Applications	
Year	2017-2023
Make	Ford
Models	F250/F350/F450 (4WD)

AIRIDE

TECH BULLETIN

Installation Guide Update

Diagram 1

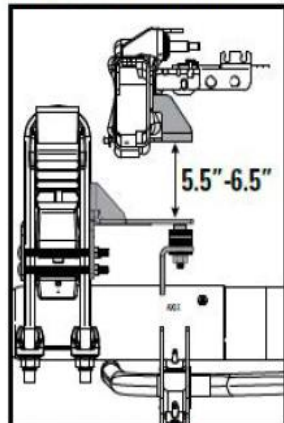
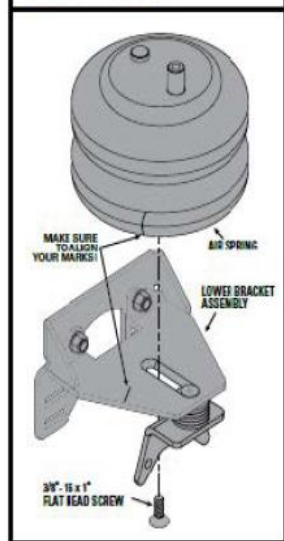
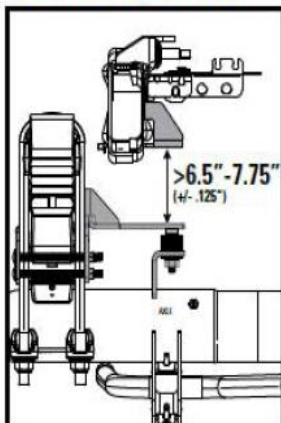
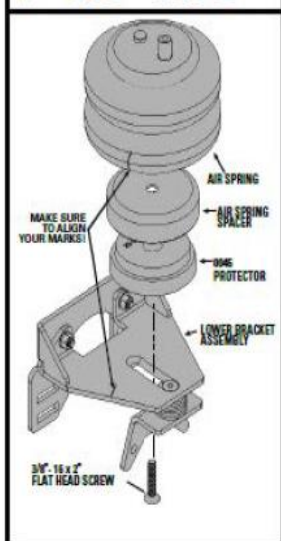
Installation Update:

- If utilizing the 1.5" spacer (5336) during the installation of 2625, 2716, 2845, or 2854, install part number 2335820045 inside the spacer to fill the gap between the lower bracket and the spacer.
- Utilizing the puck will not require different hardware to secure the air spring to the lower bracket. See "Diagram 1".
- If your kit did not come with part number 2335820045, or if you need additional information, please contact tech support at: 800-888-0650 or email rrtech@fsip.com.

Installation Update:

- When securing the air springs to the lower brackets, use part number 3514 (1.0" Flat Head Cap Screws) when the 1.5" spacer (5336) is **not** being used.
- When using the 1.5" spacer (5336), use part number 3430 (2.0" Flat Head Cap Screws) to secure the air spring to the air springs to the lower brackets.
